Gumti Textile Ltd.

Plot # 1163, Chandra, Shafipur opp. of Ansar Academy, Kaliakoir, Gazipur, Bangladesh
(24.029842, 90.266881)

20th December 2020 & 13th Jan 2021

Observations

Roof layout

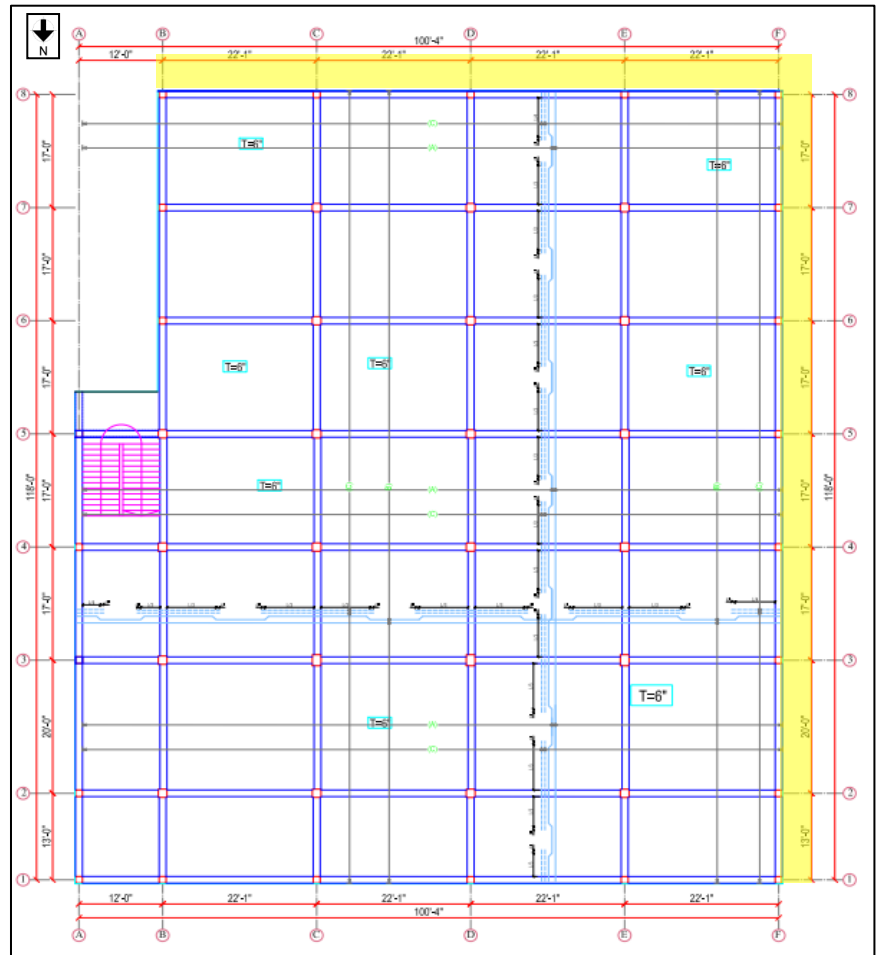
RCC water tank is shown on the drawing but on site there is one plastic water tanks on roof top having capacity of 3000 liters.

There is a slab cantilever area at south and west side that has not shown in the drawing. The width of the cantilever slab is approximately 600 mm.

Retrofitted foundation section

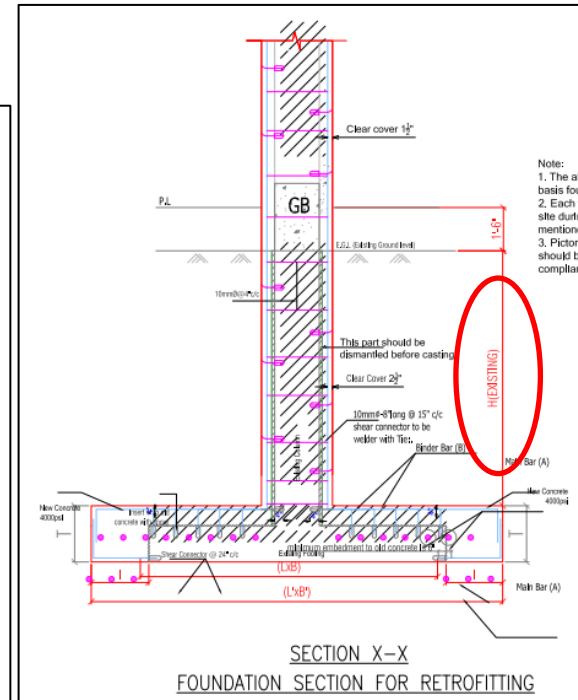
The foundation depth in the structural drawing and retrofitting drawing is not specified. Thus, the govern value of the bearing capacity of soil is unknown. Also, the retrofitting material concrete test was mentioned to be 27.6 MPa, but there was no test report to confirm the strength of the retrofitted foundations.

The revision of DEA is required with provided the calculation of the foundation adequacy check for the retrofitted foundation that complies with the section 1.9.1.1 (part-6, BNBC).

No design report was available for Building E

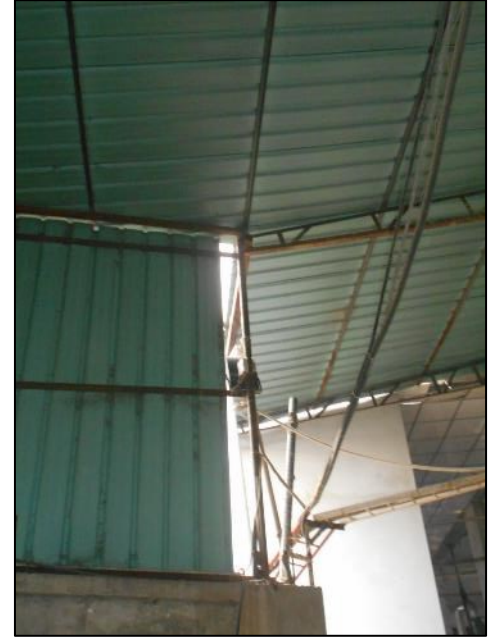
As per BNBC, every building or structure designed shall have its design documents prepared in accordance with the provision of Section 1.9.1. The design document shall include a design report, and a set of structural drawings, which shall be prepared in compliance with section 1.9.1.1 and section 1.9.1.2 as per BNBC. At the time of inspection, only as-built drawing and geotechnical report were available, but no design report was available which is required to be prepared in compliance with section 1.9.1.1 (part-6, BNBC).

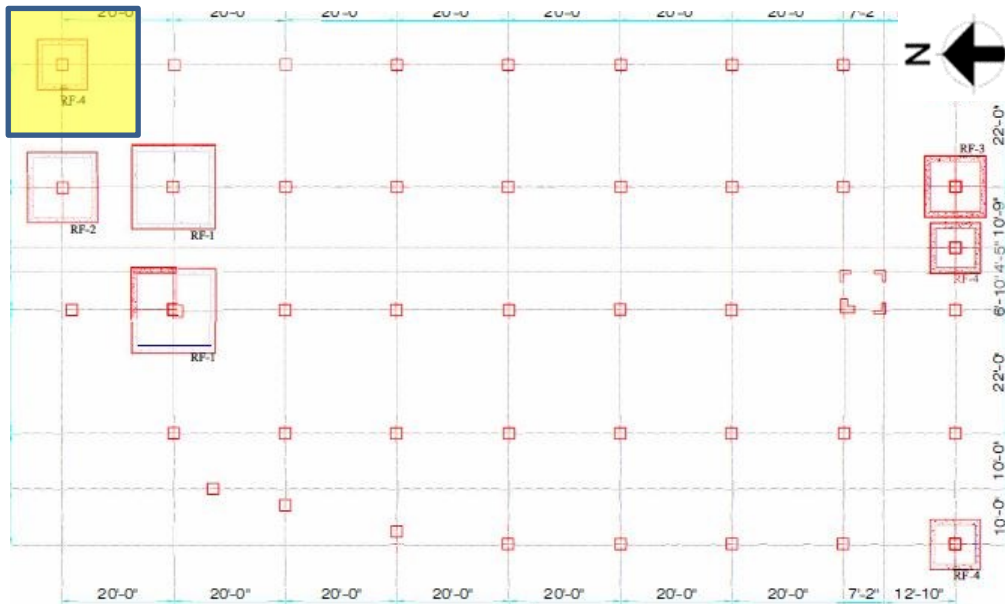
Walkway shed among the corridor of Building A, Building E, Utility building and Shed C. Mostly improper connection found on site.

No defined structural system is present on this walk way shed. The connection type is welded. No drawing was available for this non-engineered shed.

Retrofitting Foundation layout

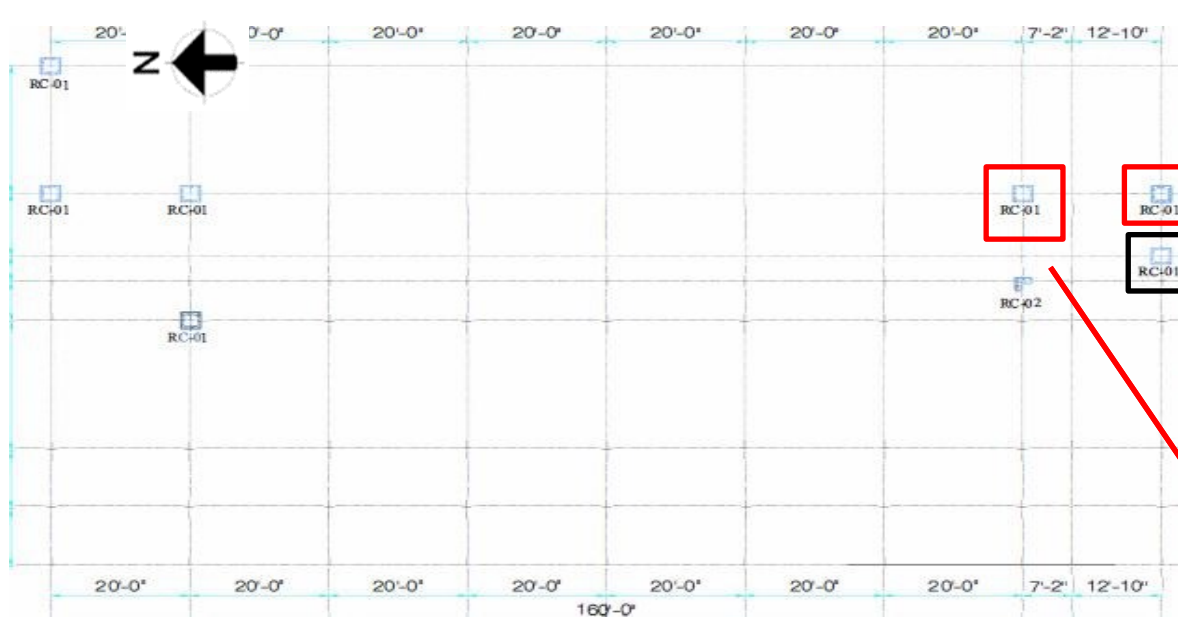
Cursory calculation indicates that the stress in foundation exceeds normal design limit. This footing is situated at the stair area and live load for this footing is considered as 4 kPa as per provided load plan.

Dimension of this highlighted footing was initially 2.13m X2.13m and dimension became 2.74mX2.74m eventually after the retrofitting work carried out for this footing. However, considering 4 kPa live load and all source of dead load this footing has been found stressed in excess of normal design limit against the soil bearing capacity available from Geotechnical investigation report. Building engineer is required to carryout foundation adequacy check to justify the load carrying capacity.

Section of grid-1 at FEA model

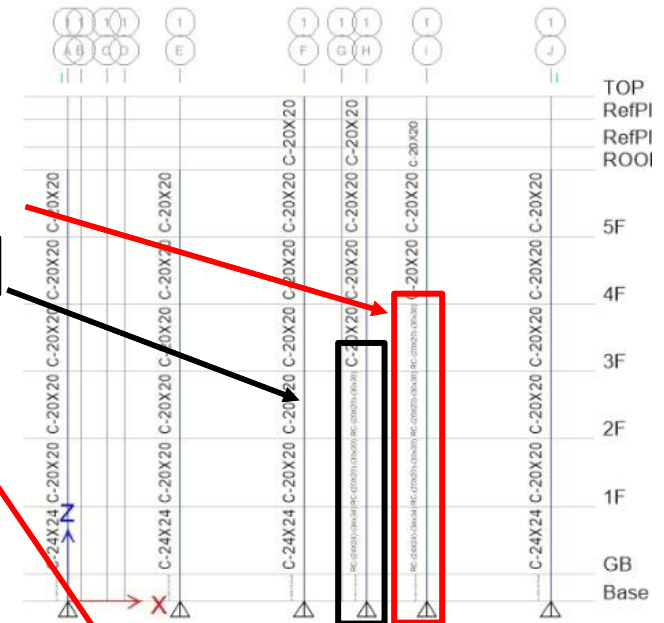
Highlighted red marked columns are considered as retrofitting up to 3rd floor roof in the design report & software-based analysis model but those columns were found retrofitted up to 2nd floor roof. Also, Highlighted black marked column is considered as retrofitting up to 2nd floor roof but those columns were found retrofitted up to 1st floor roof. Building engineer is required to review the strengthen scheme & carry out required strengthen works where necessary.

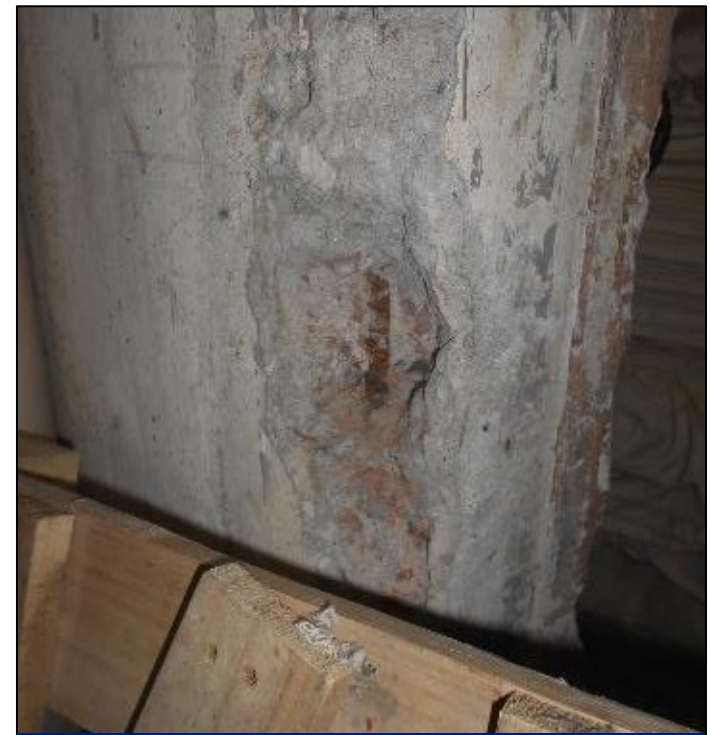
Columns were found adjacent to driveway and loading unloading platform which are susceptible to vehicle impact. Building engineer is required to take necessary measures to prevent the vehicle impact by providing the barrier around the columns.

Column layout : Damaged column location

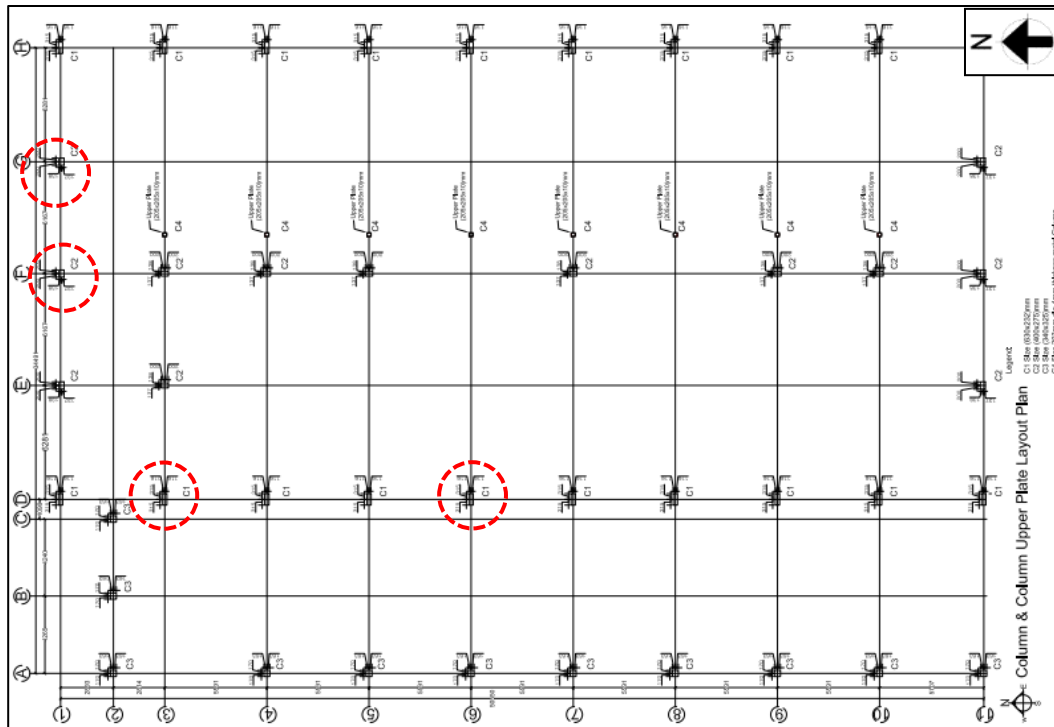
Sign of damage was found in the RCC column of shed C. Corroded rebar was also found exposed in some columns. Factory engineer is required take proper remedial works for the affected columns.

Column layout : marked (red) columns were not present

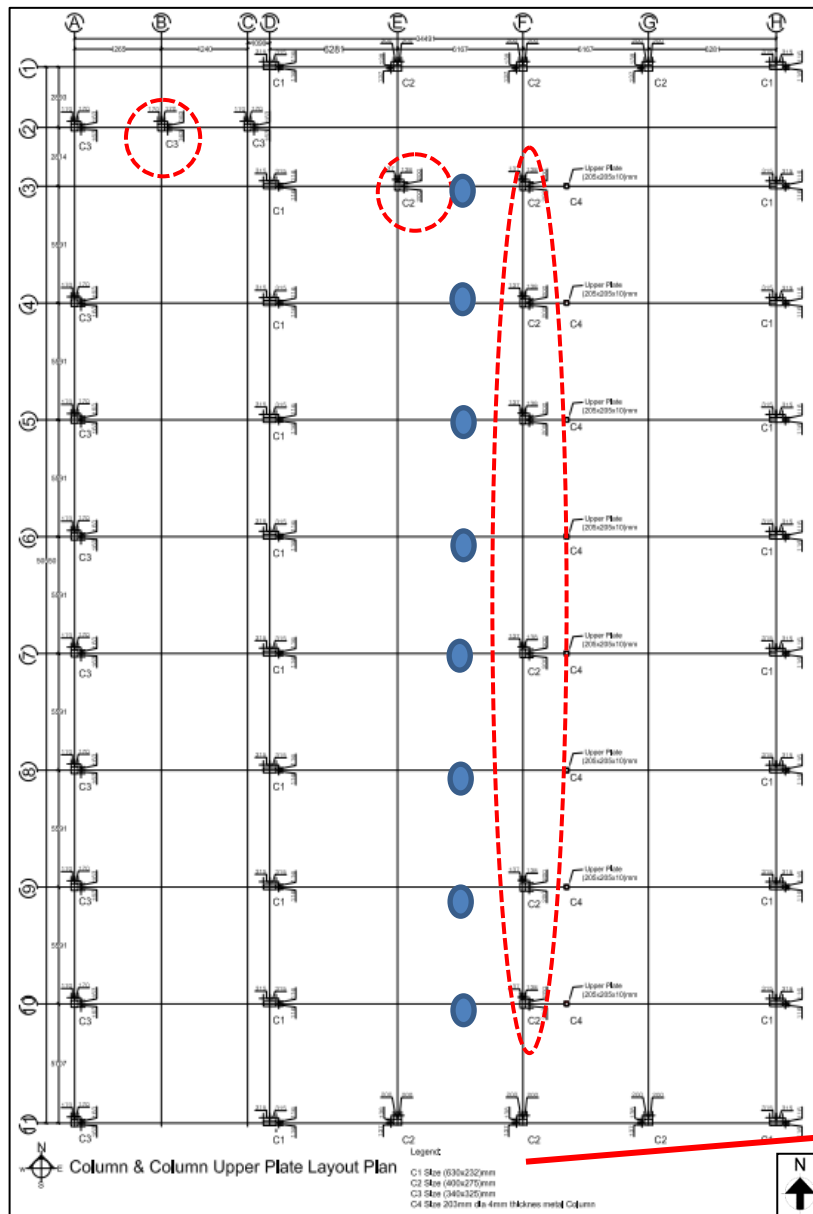
- Steel column that has not been shown on the column layout
- RC columns are along with the Grid line A , C, D H, 1, 11.

Column layout does not match with site condition. The marked (red) columns were not observed during inspection. RC Column was not found on Grid B-2, E-3, F-3~10. Additionally steel column was found on the Grid F-3~10 which was of same dimension as C4 type column. The dimension of C1 type column was found 630 mm by 210 mm instead of 630 mm by 232 mm. The dimension of C3 type column was found 300 mm by 300 mm instead of 340 mm by 325 mm. The dimension of C4 type column was found 230 mm instead of 203 mm.
